## ADDENDUM #1

Reference: South Western Utah Youth Facility HVAC System Upgrade  
Division of Youth Corrections  
DFCM Project No. 05128430

Project Name: South Western Utah Youth Facility  
HVAC System Upgrade  
Division of Youth Corrections

Addendum No.: One (1)

## DOOR JAMB DETAIL

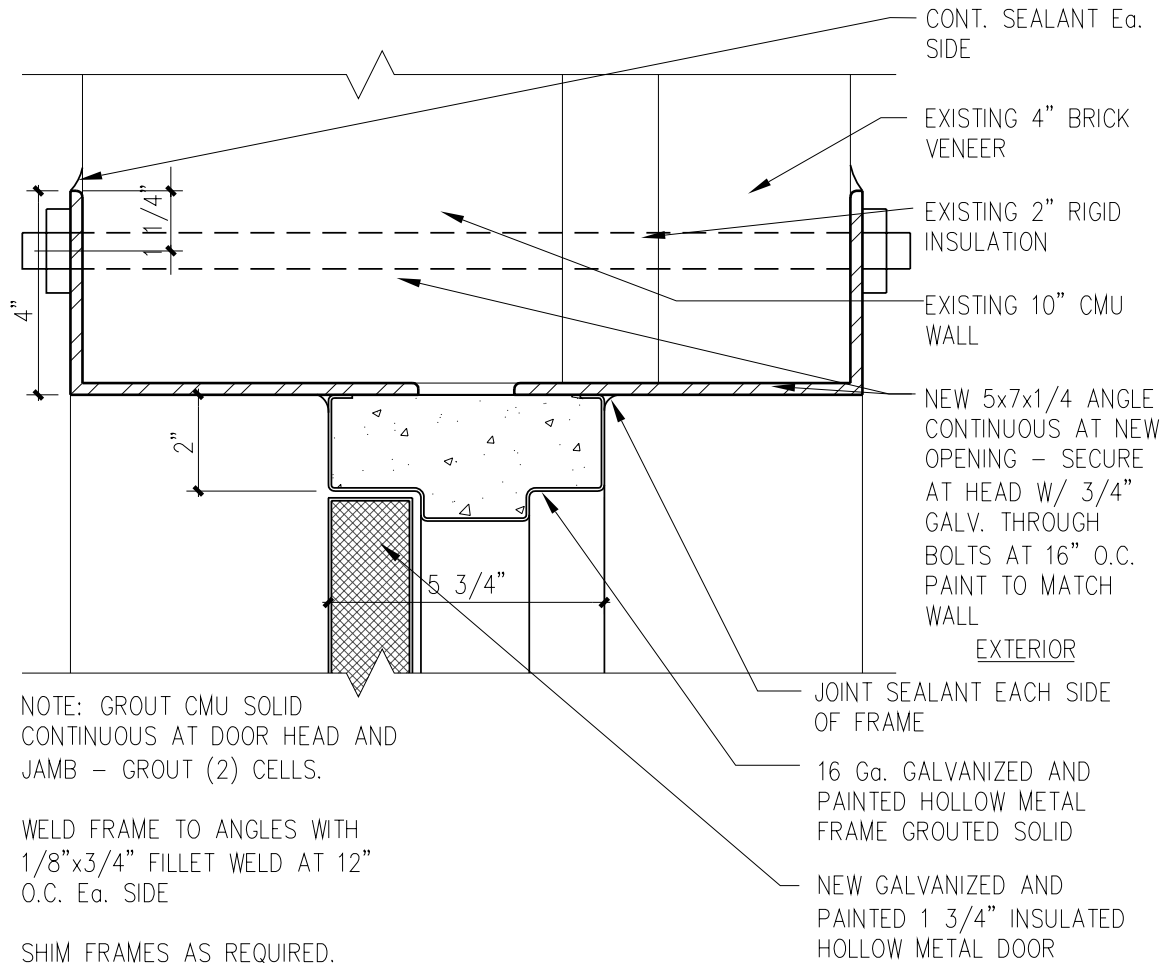
- Item VI-1.** Provide new double door into upper mechanical room for access from the roof. See attached drawings (6). Relocate the existing control box and conduits west of the new doors. Relocate the existing upper roof drain drops back into the boiler room. Exit the boiler room in the south west corner. Patch all wall openings if not part of the new door installation.

SHIM FRAMES AS REQUIRED.
